PROJECT: Structural Engineering for the Carriage Lane Project to be built in the City of Sacramento, California

SUBJECT: Revised Cable Layout for Buildings 100 & 200

Re: Carriage Lane I Townhomes
Subj: RFI #2 - Misc. Framing Questions

Re: Carriage Lane I Townhomes
Subj: RFI #3 - Misc. Framing Questions

CARRIAGE
LANE I
BLDG. 9

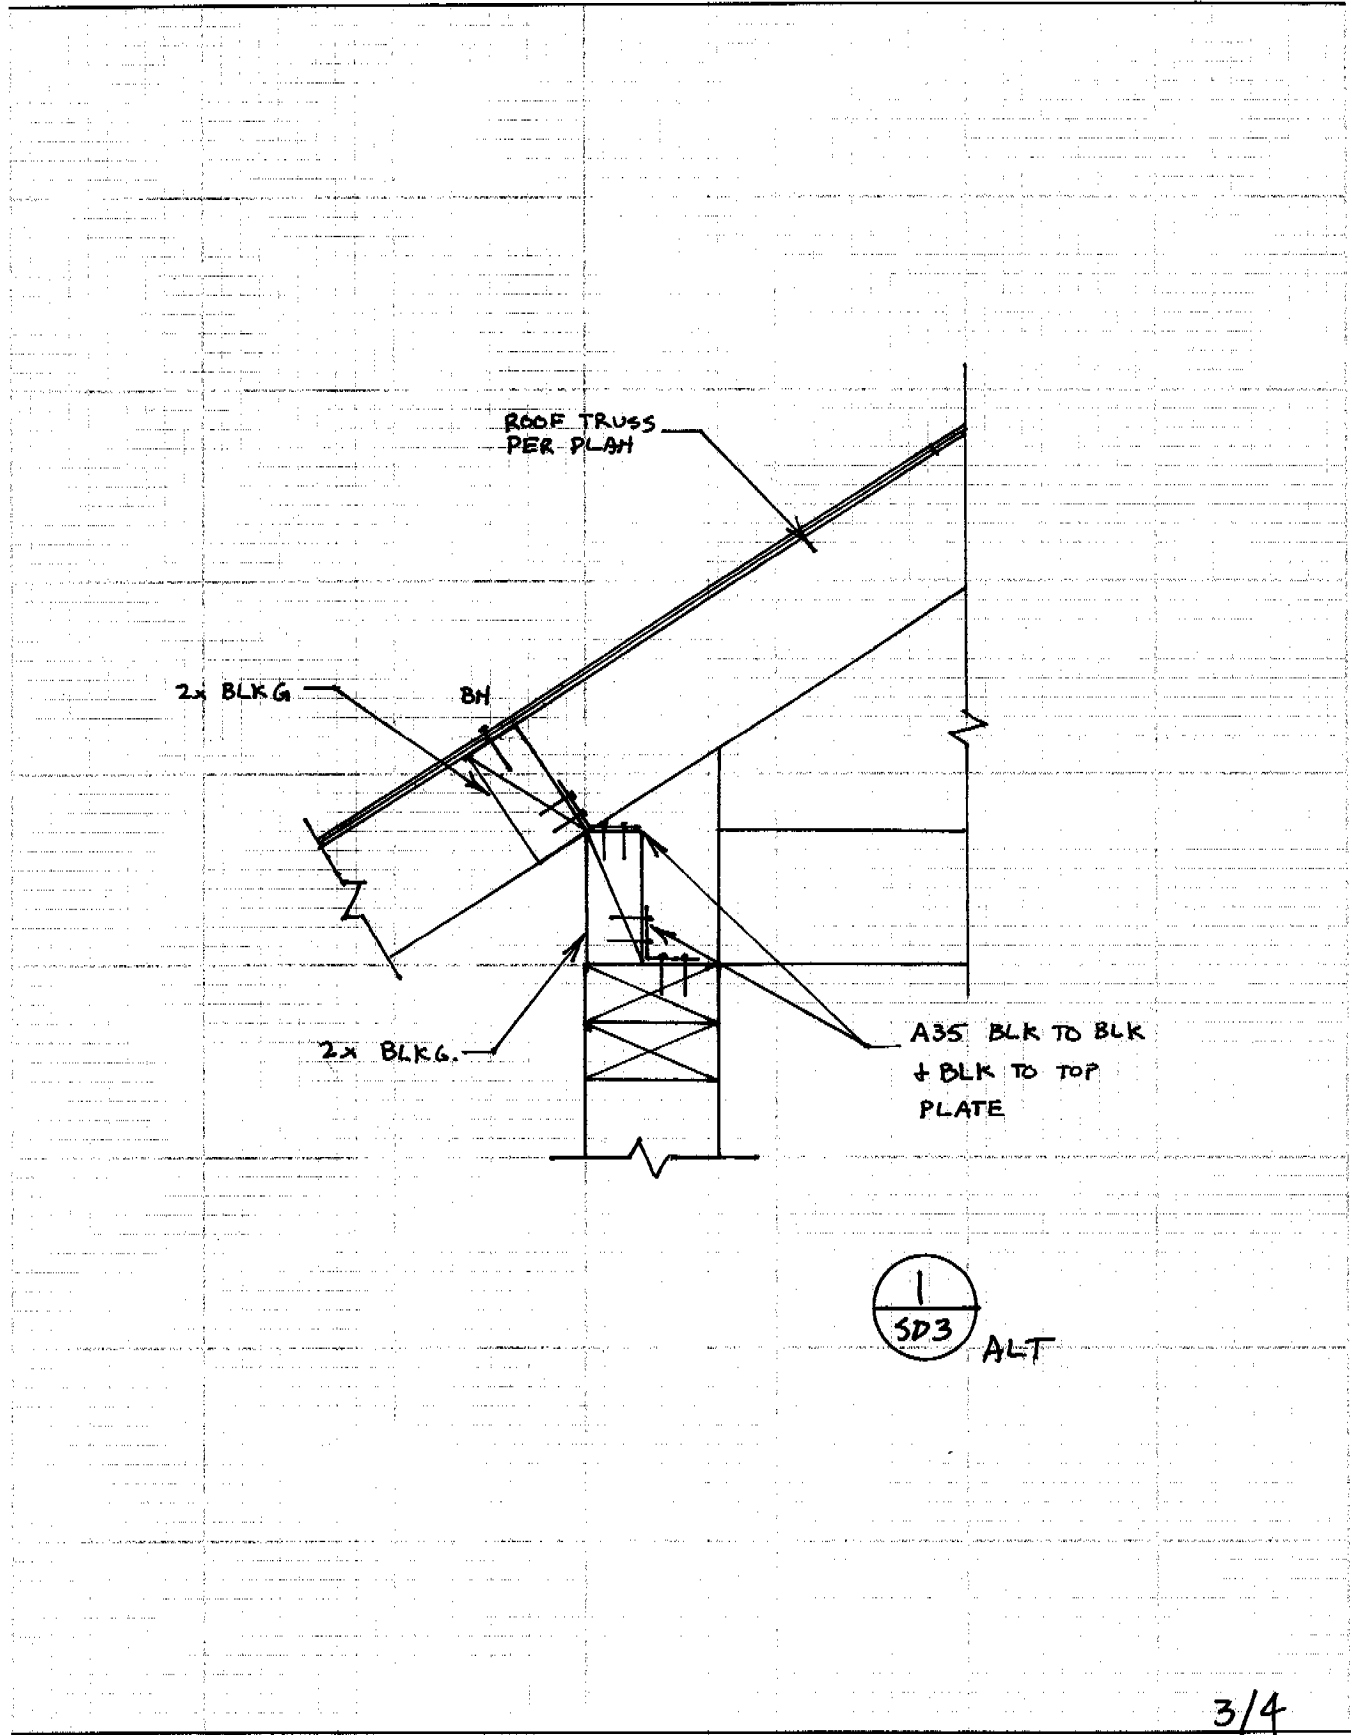
3. At the second floor Plan 5 at the Bath 2, an 8'6" type 11 shear wall is being specified. At the ends of this shear wall, CMSTC16 straps are being specified. One of the CMSTC16 is being specified per detail 1/SD4 which is a detail for installing the strap from the post above to the post below. If the shear wall is installed at the length specified, this strap will not line up with the post below but instead be installed to the face of a Strong-Wall. We were asked if this was acceptable.

The CMSTC16 should not be installed to the face of the Strong-Wall. It should be installed to the 4x6 post below. The wall length above will be revised to 7'6" to allow for this installation. Please refer to the attached page 4 for a revised drawing of this area.

PLACE STRAP HERE

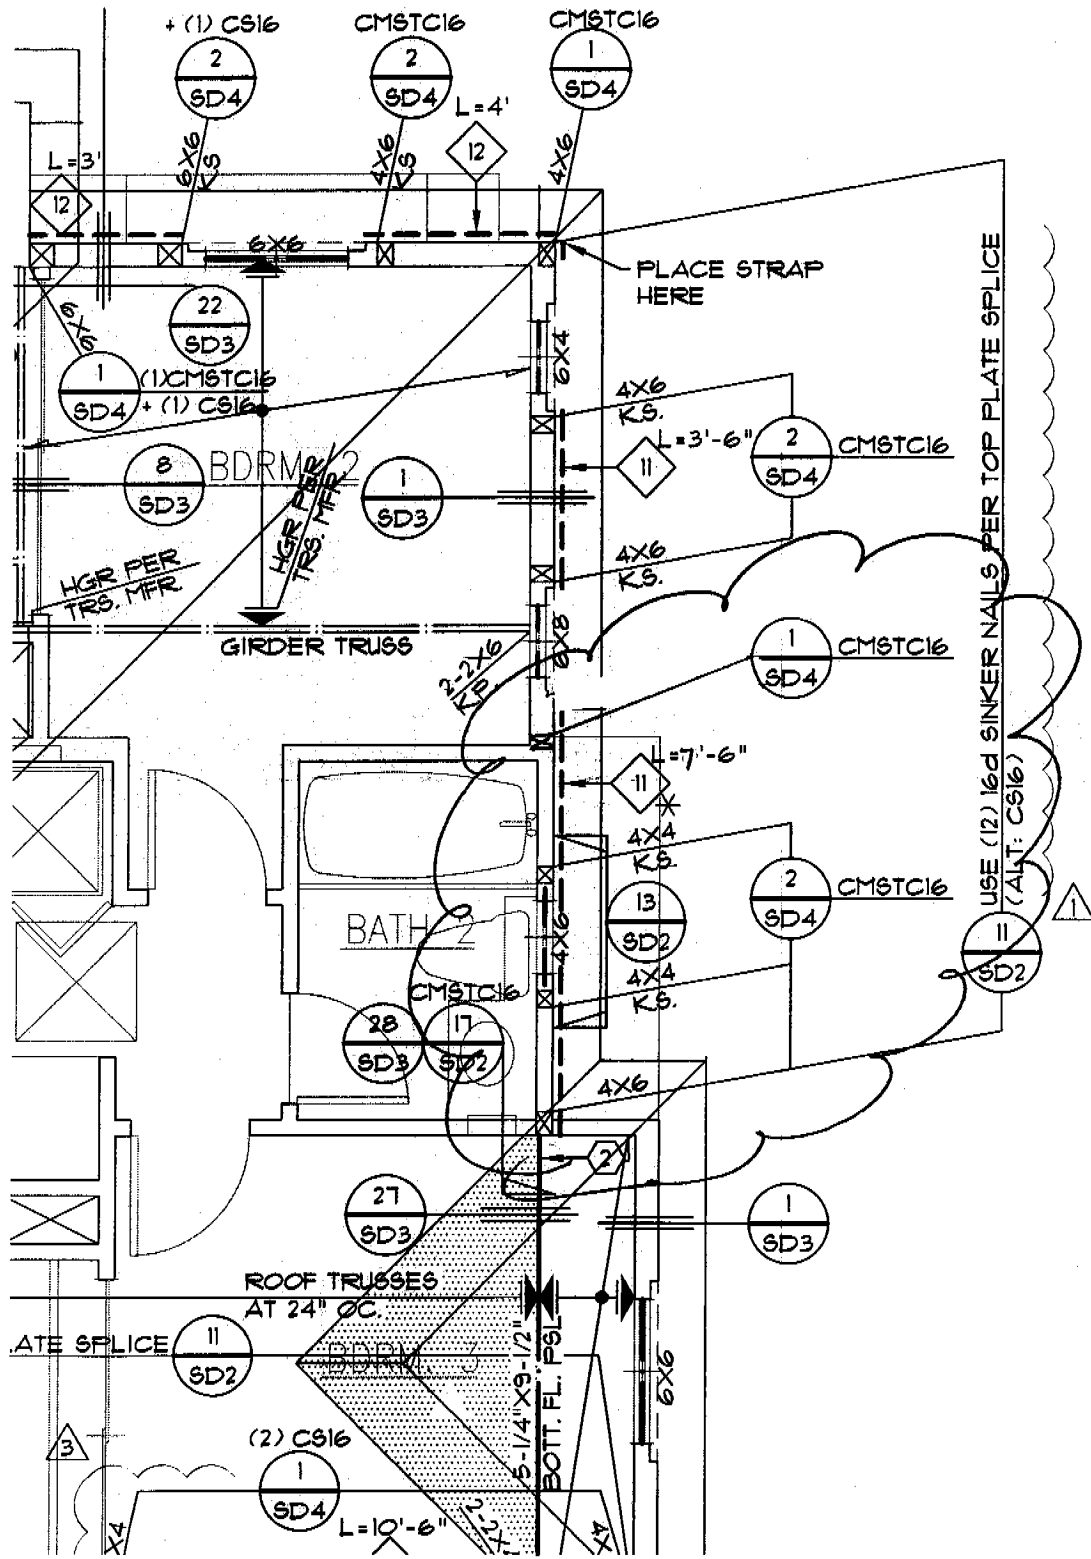
1. Our typical eave detail 1/SD4 indicates full depth eave blocks with roof BN and A35 clips to the top plates. In the model, two blocks were used and clipped together. We were asked if this was acceptable.

This is acceptable for shear transfer. See the attached page 3 for an alternate 1/SD3 detail. Note that to ease construction, we recommend that the original detail be followed on all future buildings.

CARRIAGE LANE
SHEET SD5.1

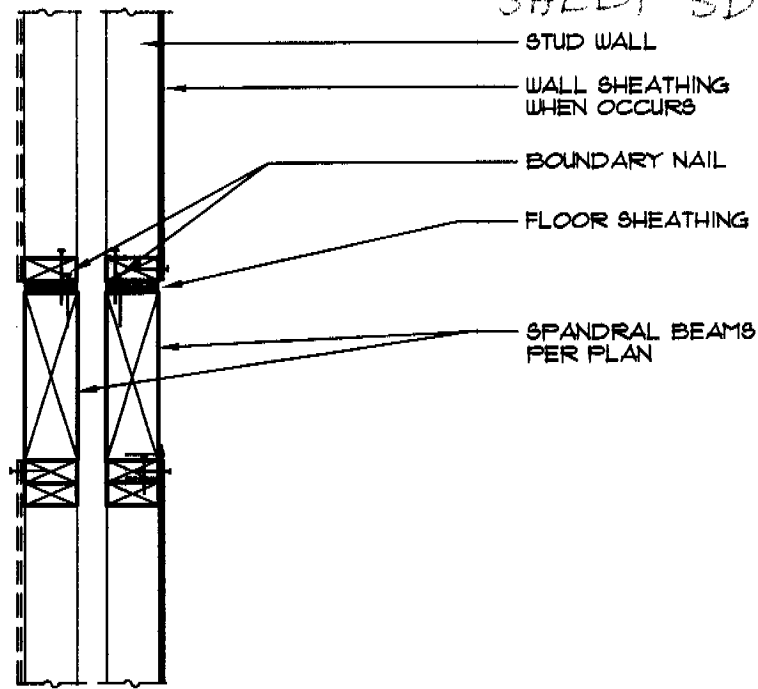
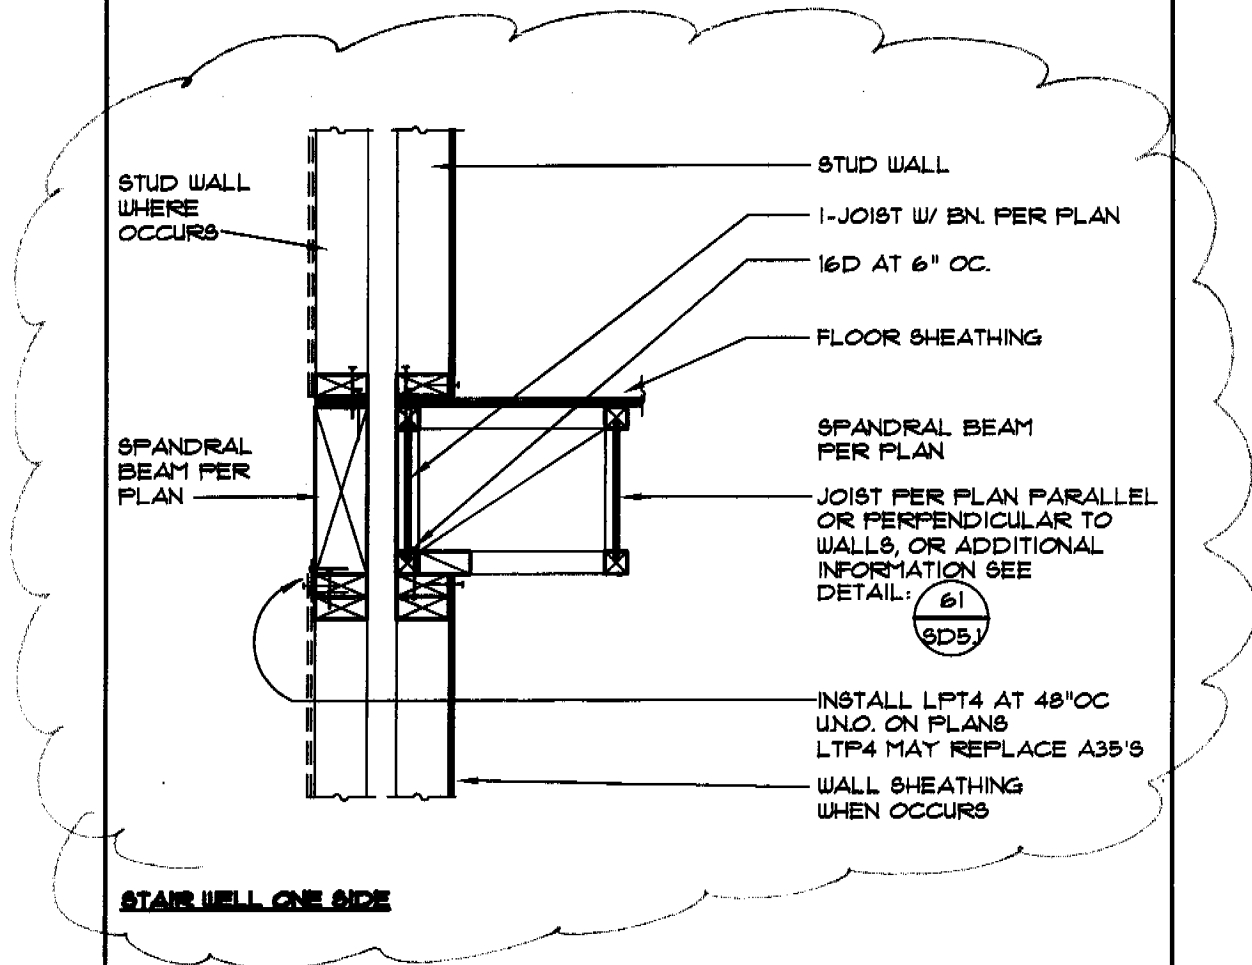
2. In building type 200, on the first floor at the party wall between the Plan 3 Living Room and the Plan 1 stairs, a 12' type 10 wall is being specified. The city inspector questioned what attachment was required from the floor to the shear wall.

At this location, detail 81/SD5.1 is specified. This detail does not clearly indicate the connection of the I-joint specified over the wall to the top plate. We have revised the detail to clarify the connection. Please refer to the attached detail for an updated detail 81/SD5.1 indicating the nailing of the I-joint to the top of the shear wall.
